We thank Mikaël Attal for his review and comments. We give detailed replies and outline the changes made to the manuscript.

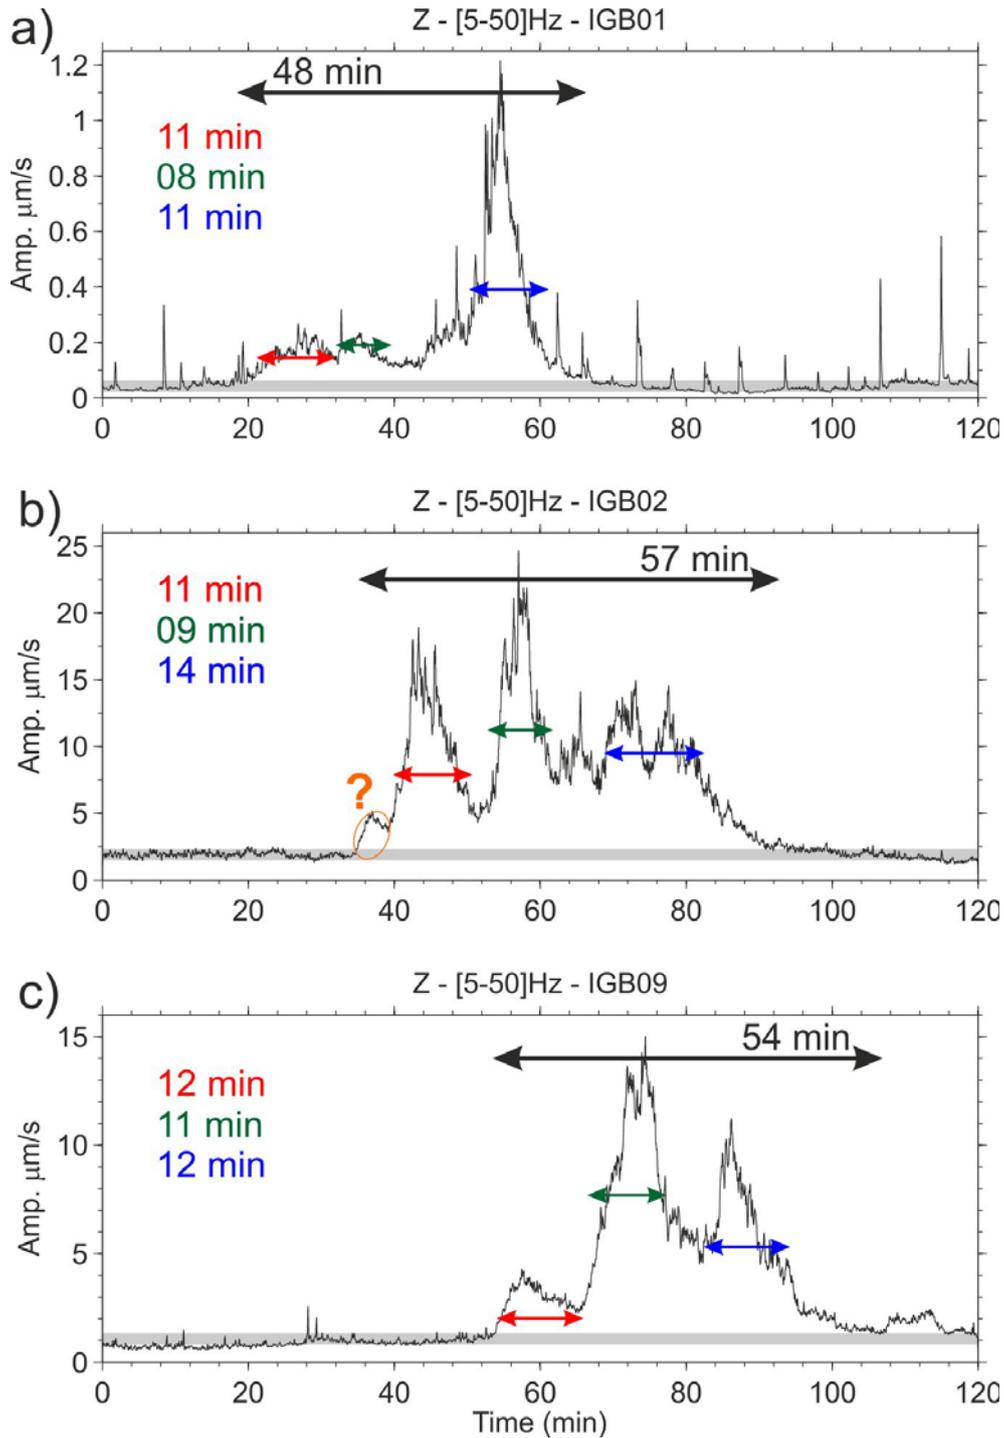
- Sections 5.1-5.2: would it possible to get more information about changes in the “shape” of the pulse from the signal recorded? I imagine pulses can stretch, form smaller pulses within a pulse and/or amalgamate (see for example recent work by Kean et al., DOI: 10.1002/jgrf.20148). So it is not just about amplitude, it is also about the duration of the pulse. If a pulse is stretched, it can decrease its maximum amplitude while not losing any energy (so in a way integrating the signal over the duration of the pulse may be more informative than looking at the peak amplitude). This could affect the interpretation page 16 (last paragraph).

In response to the referee’s request for attention to the duration of pulses, we have estimated the duration, separation and intensity of individual flow events along the trunk channel of the Illgraben. The results of this analysis add little to the estimates of flow energy and velocity summarized in Figure S3 (new supplementary material, see also Figure R1 of this document) and in the text (3<sup>rd</sup> paragraph of Section 5.3 “Comparison with *in situ* monitoring”).

The shape of a debris-flow can be seismically tracked from a station to another. We determined the total duration for this debris-flow sequence from the time the seismic signal exceeds the background level to the time it returns to this prior value (Fig. S3). The total duration is quite constant, increasing slightly inside the catchment (from 48 min at IGB01 to 57 min at IGB02) and stabilizing on the debris fan (54 min at IGB09). For the duration of seismic pulses, one key issue is to define the onset and the end of a pulse when they can overlap (e.g., 2 first pulses at IGB01) or because of their complexity (pulse 1 and 3 at IGB02). When picked manually (Fig. R1), the durations of the studied pulses were relatively similar with standard deviations of 5, 16 and 14% of the pulse duration for pulses 1, 2 and 3, respectively. For this debris-flow sequence, the impact of stretching was limited, but we shall consider these aspects in future characterizations. Details are added to the text (3<sup>rd</sup> paragraph of Section 5.3 “Comparison with *in situ* monitoring”).
